## Product Change Notice

**Issue Date: 19-September-2022**

Alternate manufacturing site for Bicolor ChipLEDs listed below.

Existing Manufacturing Site	Alternate Manufacturing Site
<b>Product Outline</b>

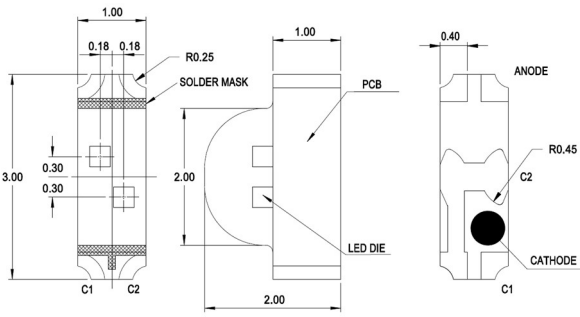
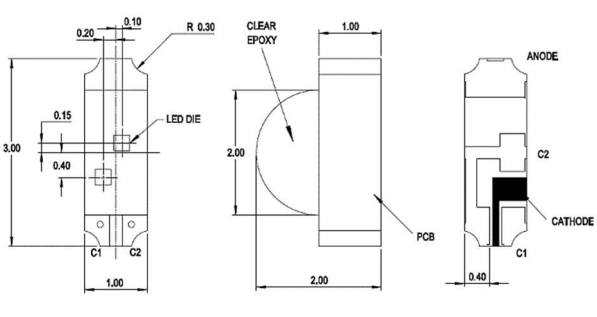
The alternate manufacturing site is qualified per Broadcom’s qualification process.

There is no change in fit, quality and reliability.
